201 Elizabeth Street – Stage 1 Modification 1

State Significant Development Modification Assessment Report (SSD 8105-Mod-1)

Council reference: D/2017/349/A

Figure 38 | Proposed variations to approved building envelope. Concept SSDA outlined in black, Concept Modification SSD outlined in red and proposed Detailed Design SSDA shaded red. (Source: Ethos Urban EIS for D/2024/854)

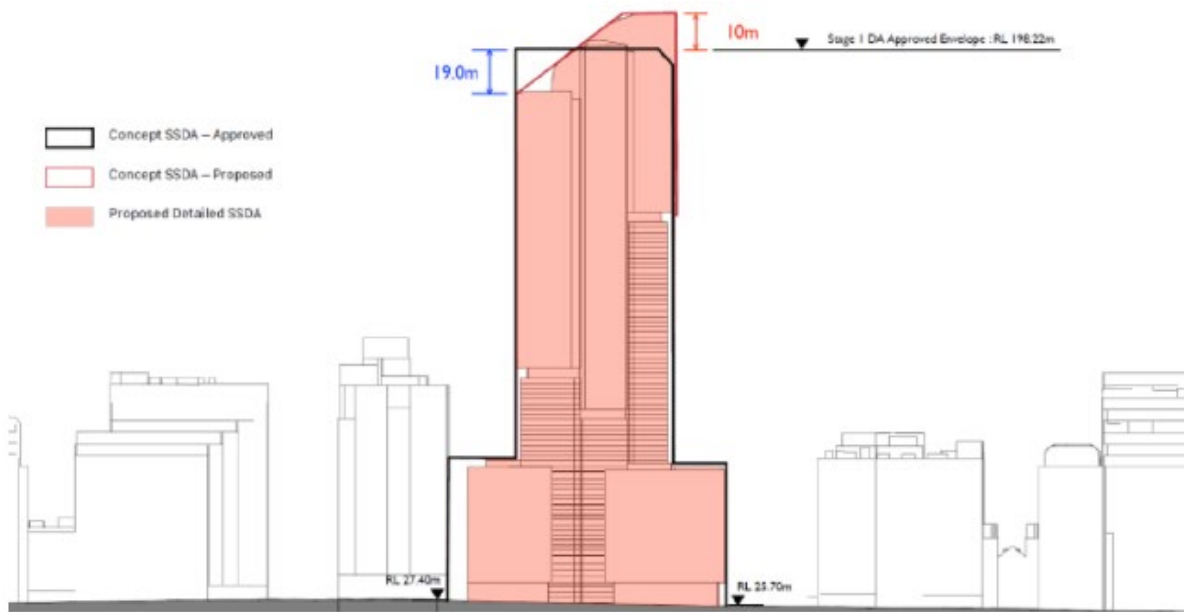
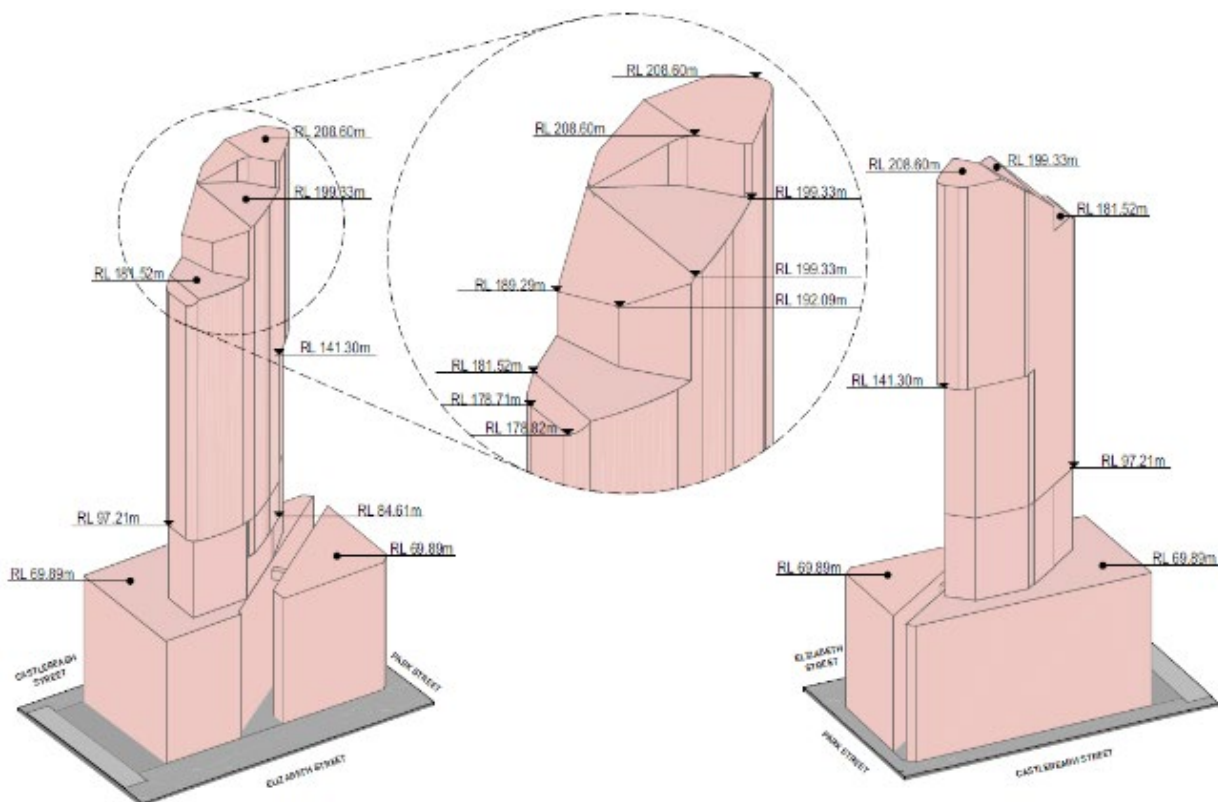
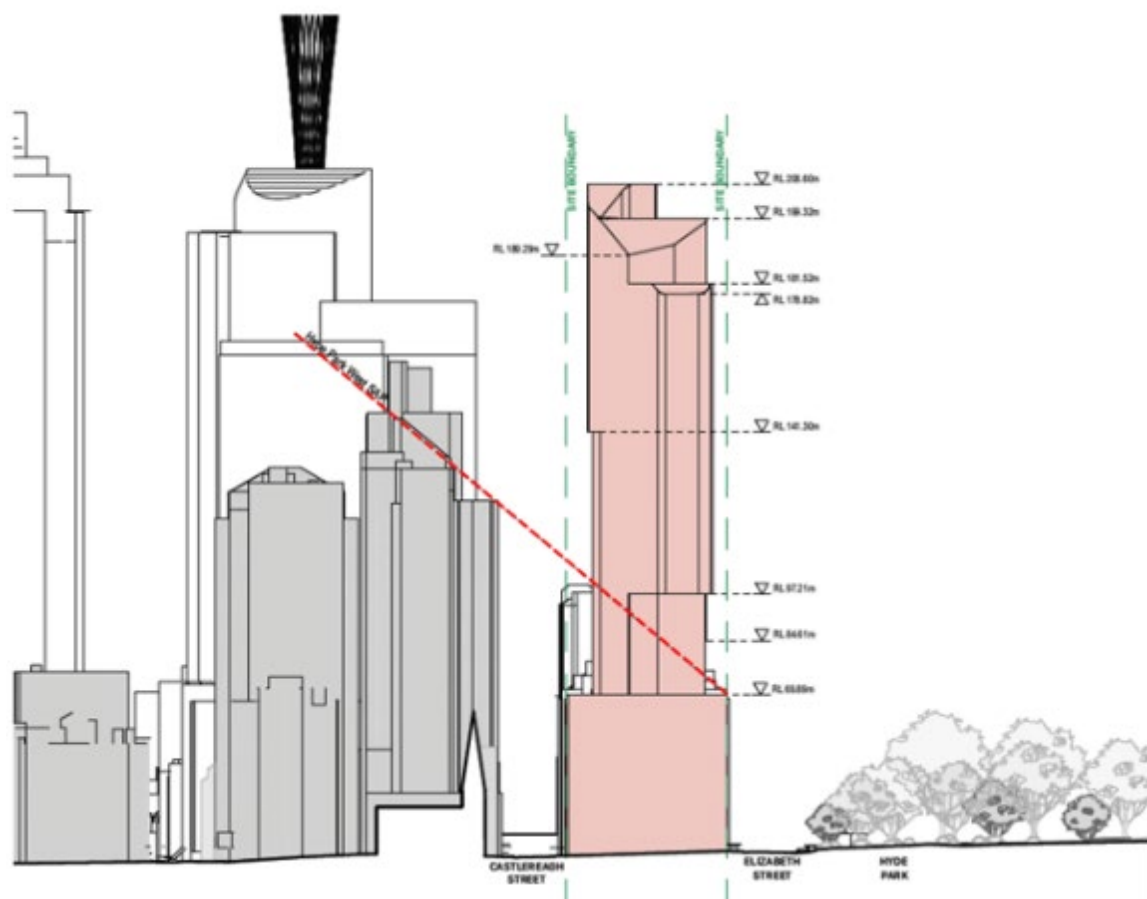
The proposed modification comprises a maximum height of RL208.60 (182.28m) at the north-western portion of the tower to align with the design competition winning scheme and Detailed Design SSDA, exceeding the approved height by approximately 10m. The proposed modification has essentially removed height from the south (up to 19m) and relocated some of that envelope to the north-west corner (approximately 10m) to create the tri-partite tower form of the design competition winning scheme. The tower elements are stepped in height. See **Figures 37-39** depicting the approved and proposed Concept building envelopes and the tri-partite tower form, as well as the Hyde Park West sun access plane.

Figure 41 | Shadow diagram 21 June 12pm (existing in blue and proposed in red) (Source: Ethos Urban Modification Report – Building Envelope Design Report)

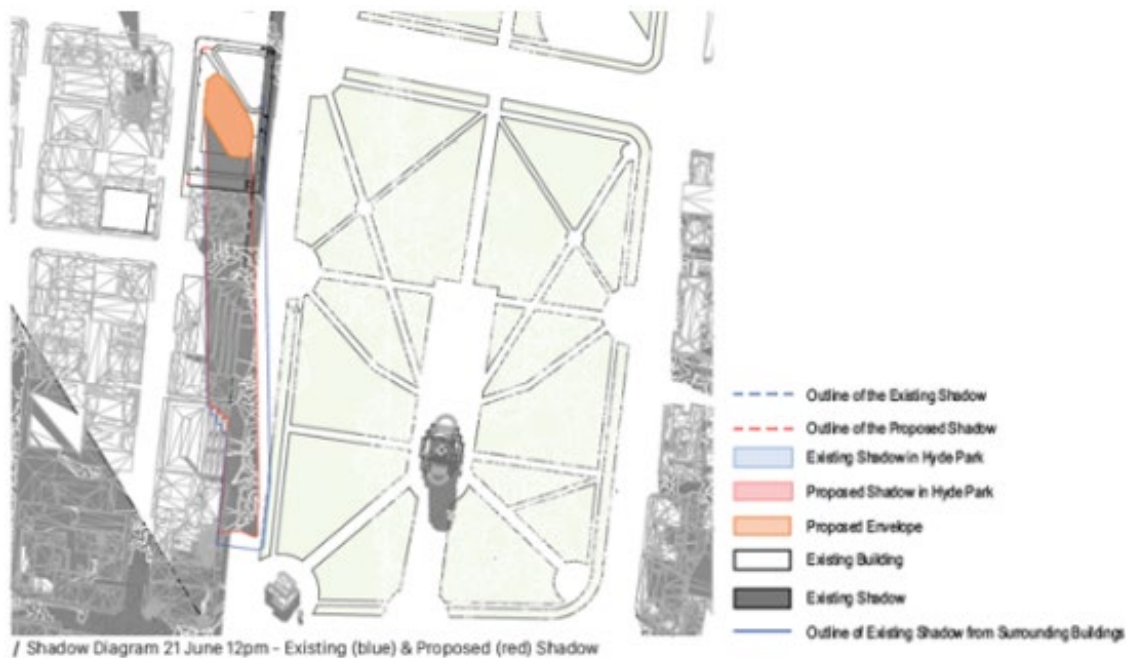
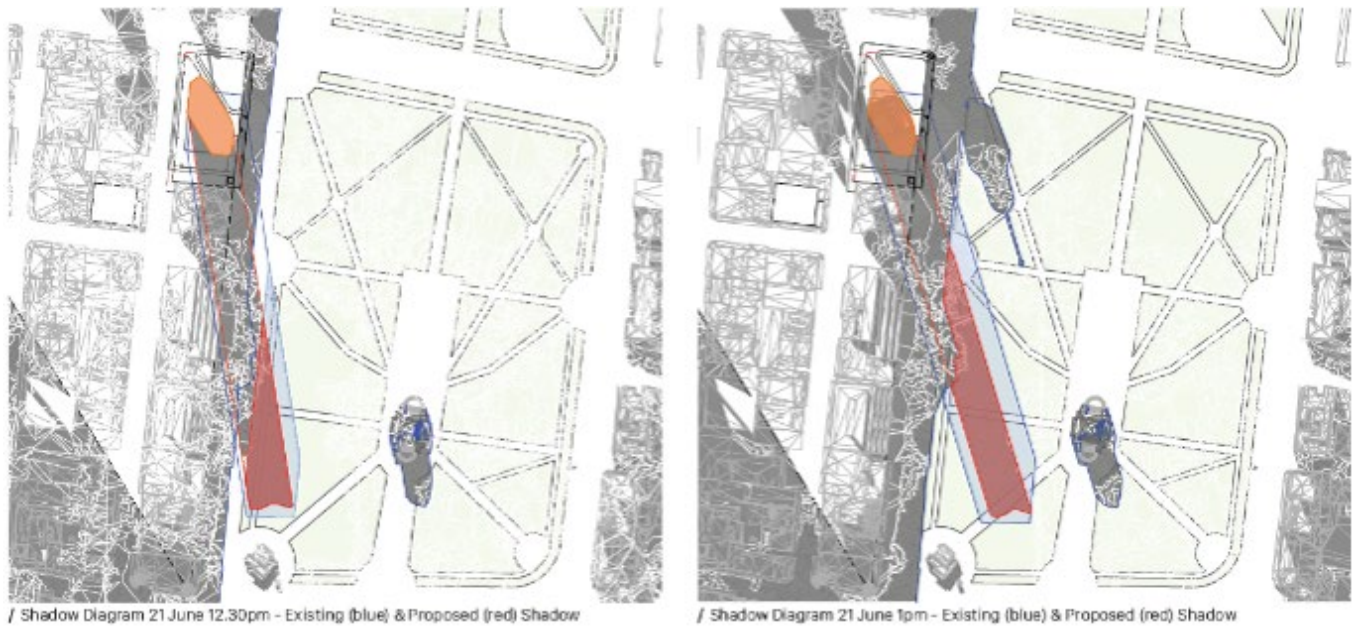
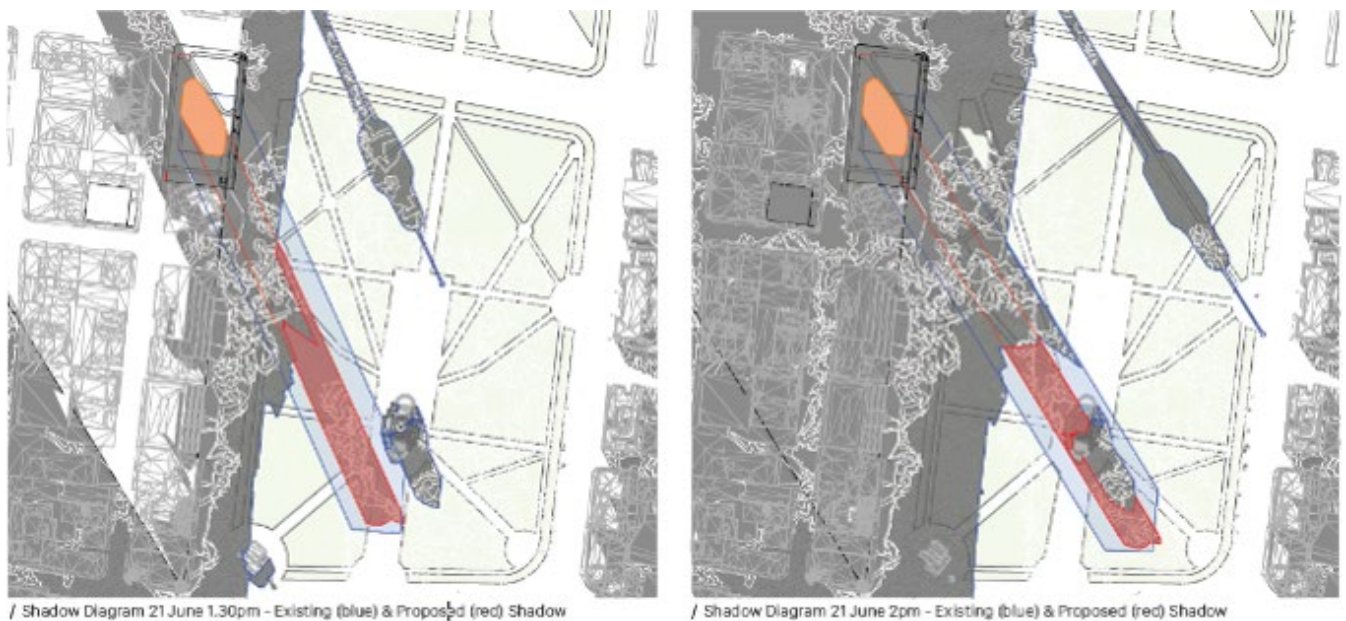
The proposal is accompanied by detailed shadow diagrams demonstrating that the proposed modification to height, and those parts exceeding the sun access plane will result in an improved outcome to Hyde Park and the Anzac Memorial. The Concept Modification SSD will achieve a 50.13% reduction, which is consistent with the Concept Approval SSD, and the Detailed Design SSDA will achieve a 51.42% reduction in shadows cast on Hyde Park between 12.00 and 14.00 on 21 June. This is a 1% improvement compared to the Concept Approval.

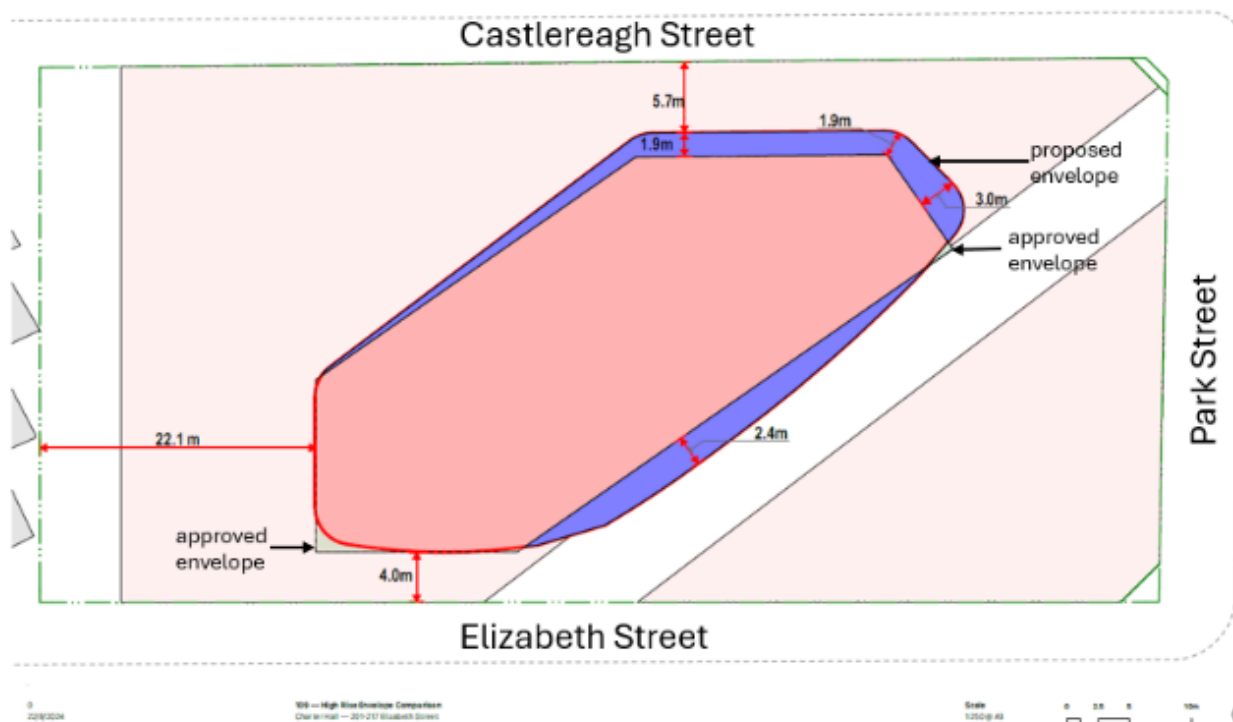
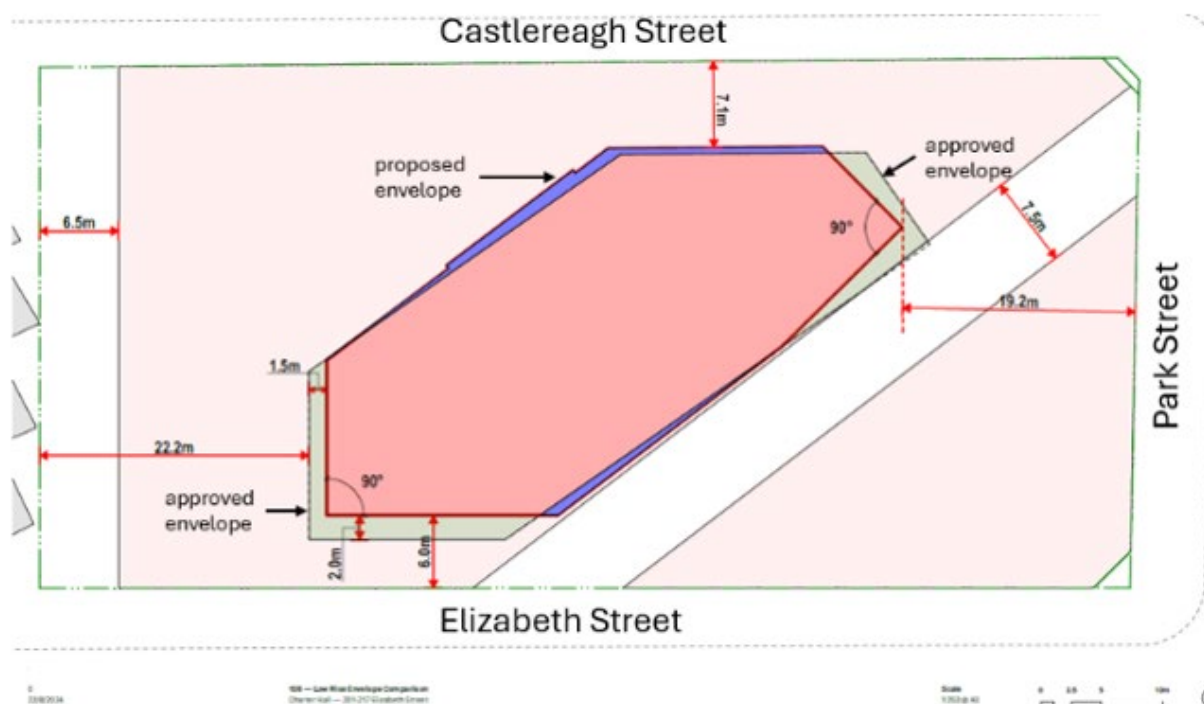
It is also proposed to reduce the Castlereagh Street setback by 1.9m, from 7.6m to 5.7m, as shown **Figure 44** below. This occurs from RL141.30 and above as part of the high-rise tower. The proposed reduction is in response to the tri-partite tower form. The shifting of the tower envelope, compared to the approved envelope, is also shown.

As demonstrated by **Figures 44** and **45**, there are portions of the proposed envelope that have been reduced compared to the approval (particularly within the low-rise tower), and areas have been added beyond the envelope (within the high-rise tower). The proposed reduction in setback to Castlereagh Street, along with the other changes to setbacks, will enable the redistribution of floor space, ensuring that the concept envelope can reasonably accommodate the permissible floor space to support a feasible development scheme. The setbacks will also preserve solar access to Hyde Park between 12.00 and 14.00 at 21 June, as discussed above.

The proposed 5.7m setback to Castlereagh Street above the street frontage height is acceptable considering:

- The new tower, with the proposed 5.7m setback occurs within the high-rise portion, whereas the low-rise tower maintains a setback of 7.1m which is generally consistent with the Concept SSD. The largely imperceptible change to the setback starts from RL141.30 and occurs across approximately 22% of the Castlereagh Street frontage at these levels;

Figure 67 | Viewpoint: Victoria Tower (level 14, apartment 1403A). Red dashed lines indicate area not approved by D/2017/349. A setback of 17m was required by Condition 2 of the deferred commencement consent. (Source: Ethos Urban Modification Report – View and Visual Impact Analysis)

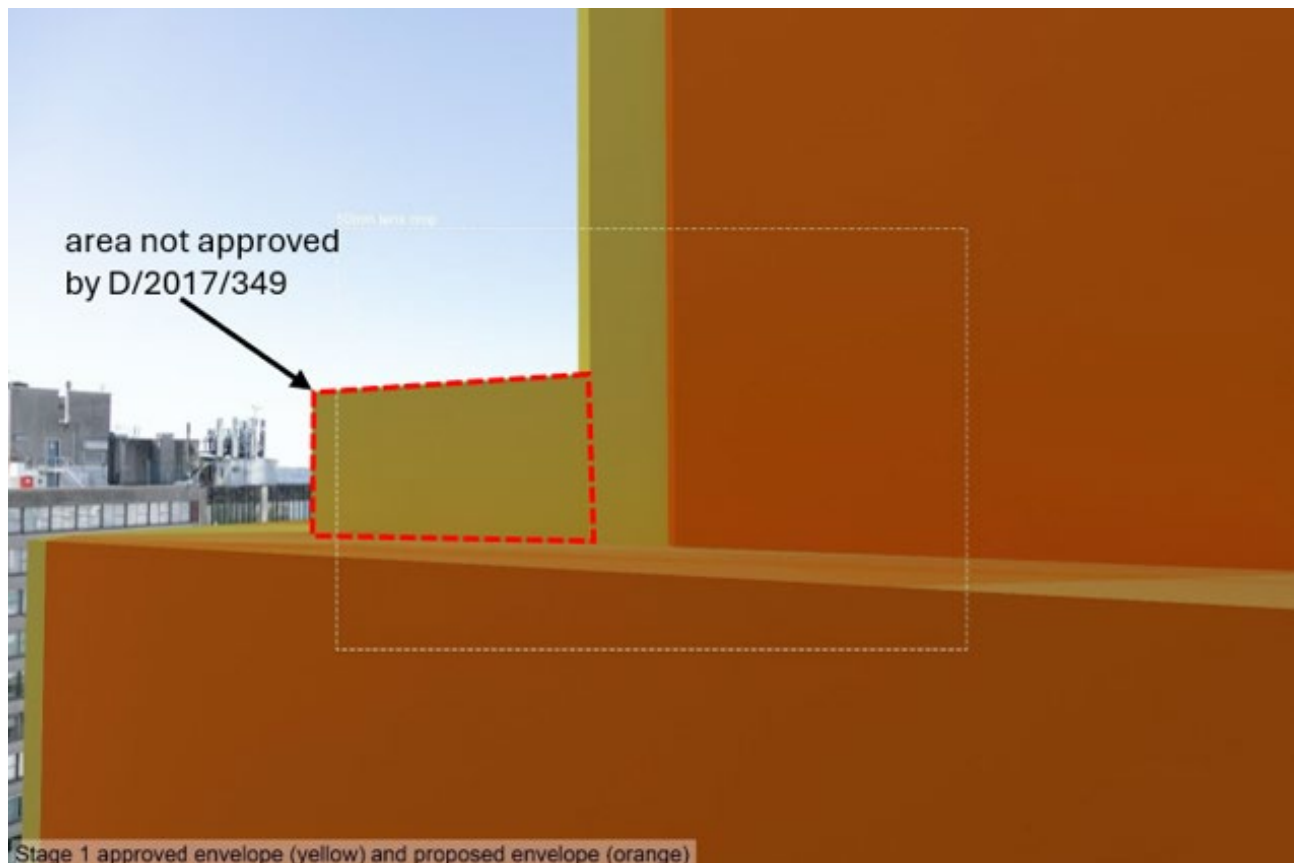
It is noted that the area of the approved envelope that extends above the podium was conditioned to be deleted as part of the deferred commencement conditions. See **Figure 67** below.

Notwithstanding, the proposed tower is setback 19.2m at this level (compared to 17m for the Concept SSD Approval) which improves views across this sightline.
